Source: TSG CN WG1
Title: CR to Rel-6 WI "TEI6" for TS 43.068, 43.069 and 24.008
Agenda item: 9.21
Document for: APPROVAL

This document contains 7 **CRs on Rel-6 Work Item "TEI6"**, that have been agreed by TSG CN WG1 CN#37 meeting and forwarded to TSG CN Plenary meeting #27 for approval.

⌘ **24.008 CR 932** ⌘ rev **-** ⌘ Current version: **6.7.0** ⌘

Title:	⌘ Correction of the heading of subclause 4.7.3.1.6, bullet d.1		
Source:	⌘ Siemens AG		
Work item code:	⌘ TEI6	Date:	⌘ 01/02/2005
Category:	⌘ F	Release:	⌘ Rel-6
	Use <u>one</u> of the following categories: F (correction) A (corresponds to a correction in an earlier release) B (addition of feature), C (functional modification of feature) D (editorial modification) Detailed explanations of the above categories can be found in 3GPP TR 21.900 .		Use <u>one</u> of the following releases: Ph2 (GSM Phase 2) R96 (Release 1996) R97 (Release 1997) R98 (Release 1998) R99 (Release 1999) Rel-4 (Release 4) Rel-5 (Release 5) Rel-6 (Release 6) Rel-7 (Release 7)

Figure 4.7.3/1 3GPP TS 24.008: GPRS attach procedure and combined GPRS attach procedure

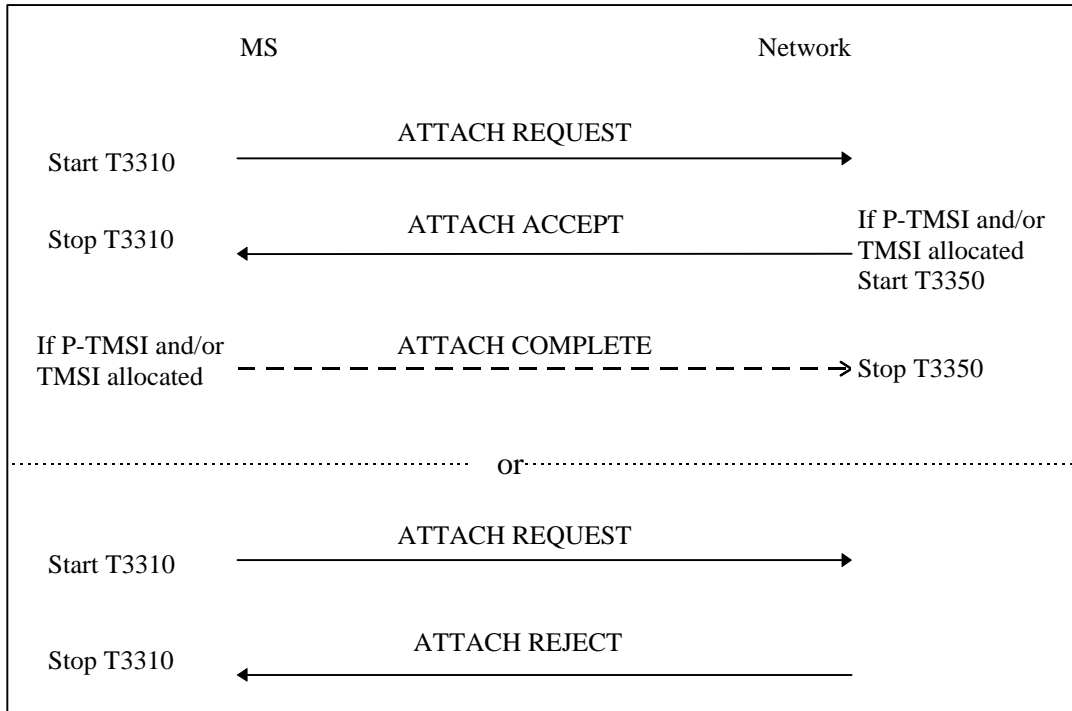
Reason for change:	⌘ With CR 04.08-A467r2 (P-99-456), bullet d of the abnormal cases during GPRS attach for the network side was split in two parts, d.1 and d.2. The 'virtual' mirror CR for R98, CR 04.08-A753r2 (see SMG#30, P-99-554), was not implemented correctly, since part of the heading of d.1 was lost.
Summary of change:	⌘ Addition of the missing part of the heading.
Consequences if not approved:	⌘ The description of the abnormal case d.1 is incomplete, since part of the description was only given in the lost part of the heading.

d.1) ATTACH REQUEST received [after the ATTACH ACCEPT message has been sent and before the ATTACH COMPLETE message is received](#)
